ADDENDA #3

October 27, 2021

Bid # RFB-2021-39

SUNY SCCC WELCOME CENTER

Addendum #3 : SK-01 Project Site Access and Lay Down Area
Not to Scale

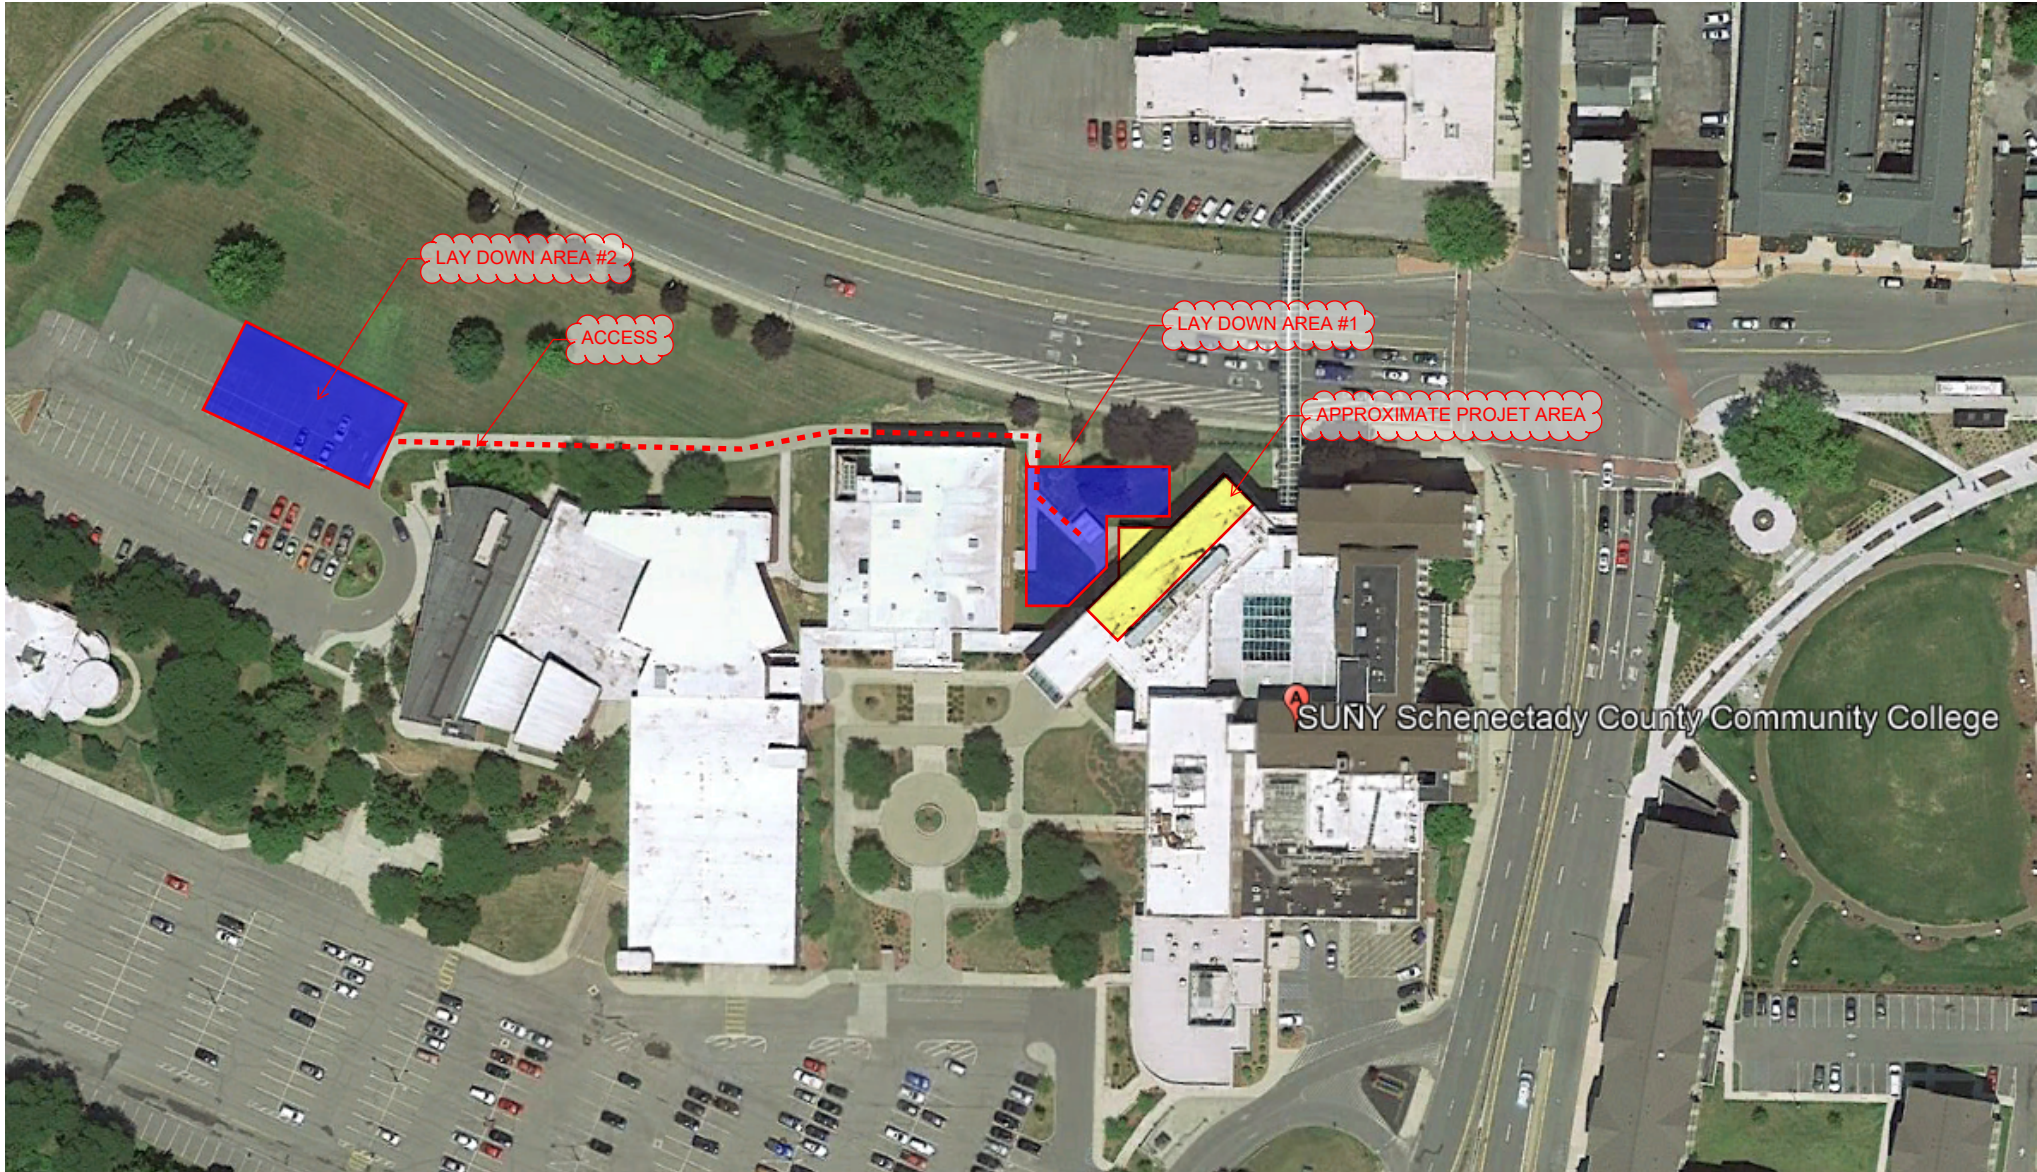
- SK-01: Project Site Access and Lay Down Area.
- SK-02: Construction Phasing Plan
- SK-03: Bid RFI #02 Response

Addendum #3 : SK-02 Construction Phasing Plan
Not to Scale

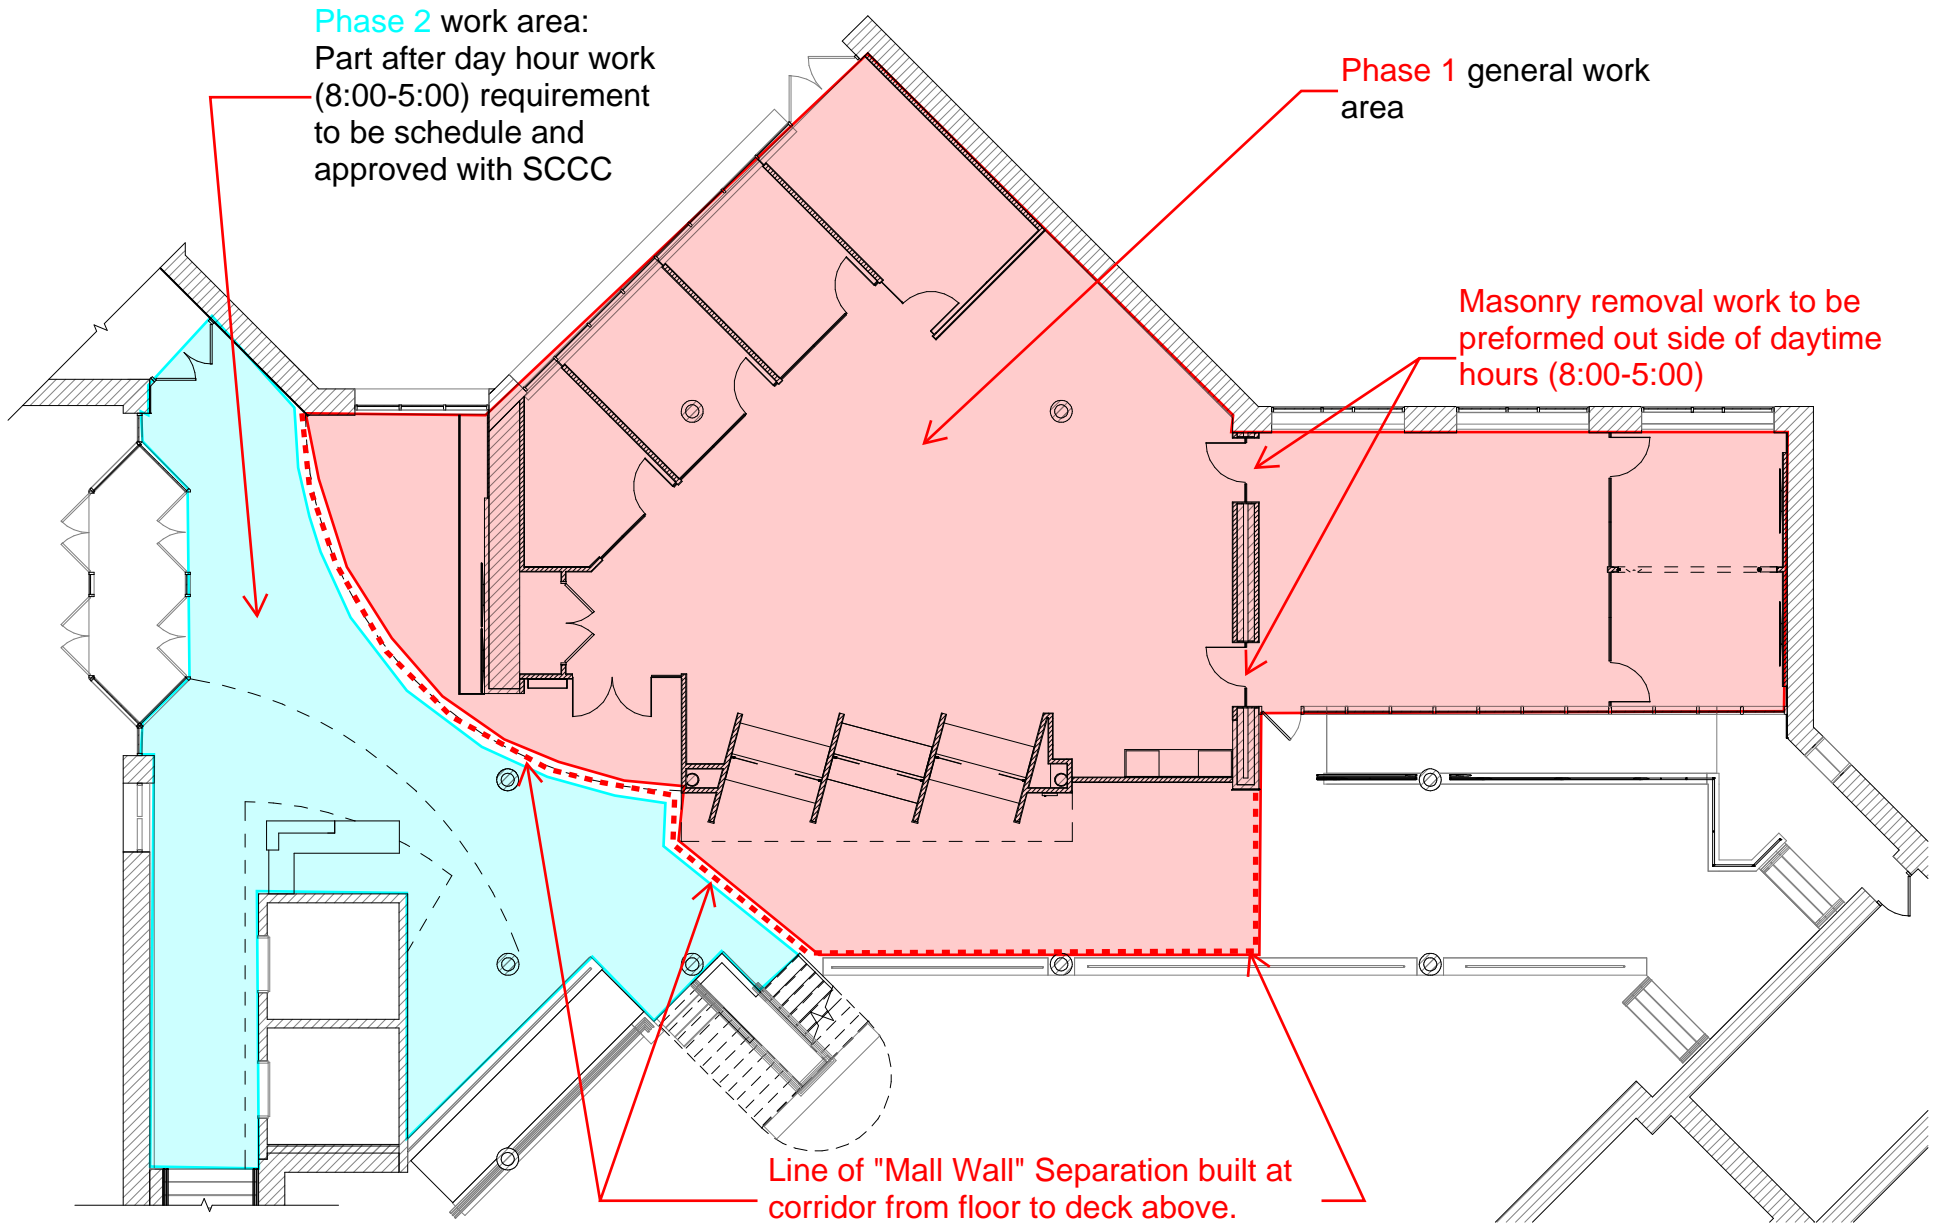
4. Please provide a logistics plan that identifies project requirements for segregating construction activities from public access.
 - a. Response: See sketch SK-02 Construction Phasing Plan.

Addendum #3 : SK-03 RFI #02 Response
Not to Scale

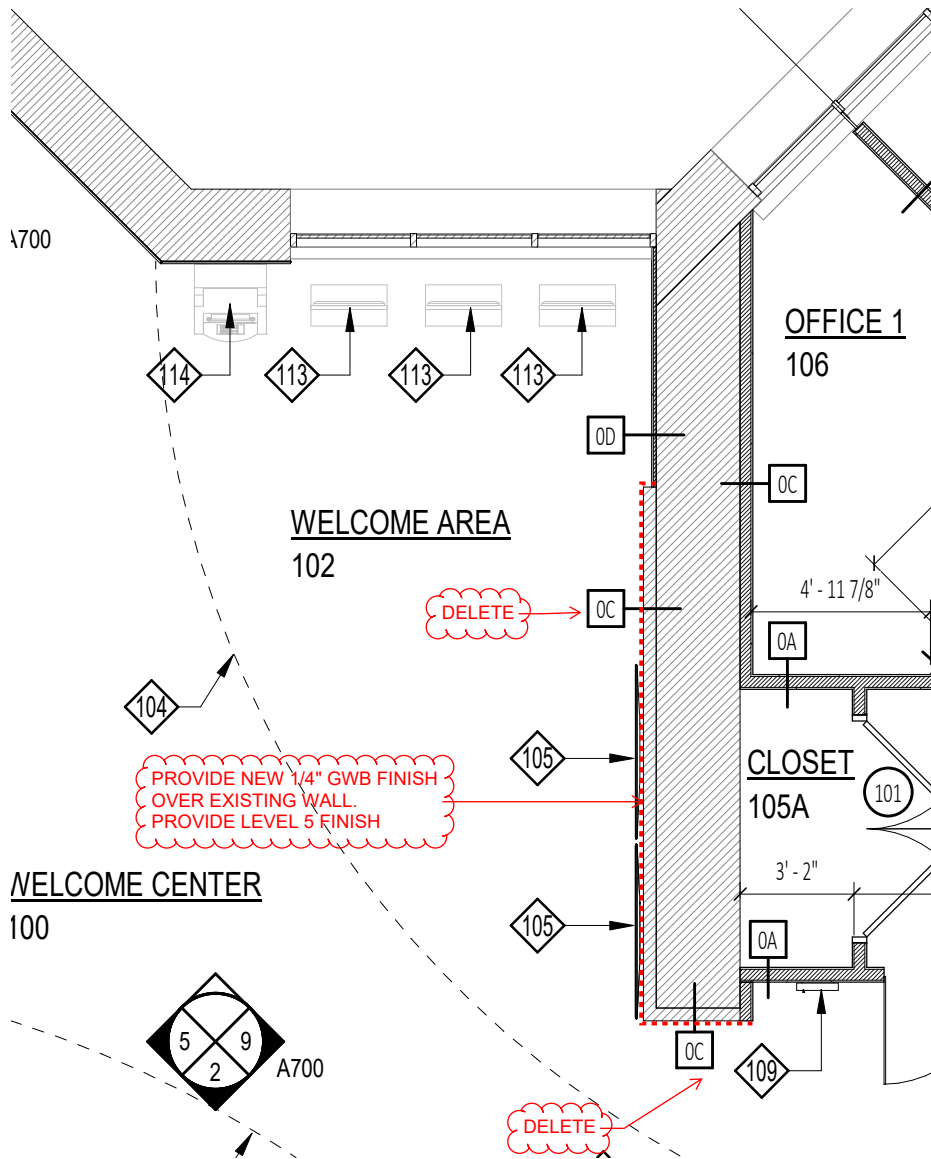
- Welcome Area 102:
 - See attached sketch SK-03 for area wall type revisions and notes.

1. No lintel details and requirements are provided for the wall openings in the masonry walls for the doors 107 and 108.
 - a. Response: The existing masonry only extends above the existing ceiling and is not load bearing for the structure above.
2. The floor plan in Welcome Area room 102 calls out for a new OC wall type, but points out at the existing wall.
 - a. Response: See attached SK-03 for revisions and clarifications.
3. On the floor plan the doors 110 and 111 have the Keynote Legend 106 suggesting that these two doors and glass wall systems are part of the Alternate #2?
 - a. Response: See response above for Drawing A100/Detail 1 revisions at Huddle rooms 1&2.
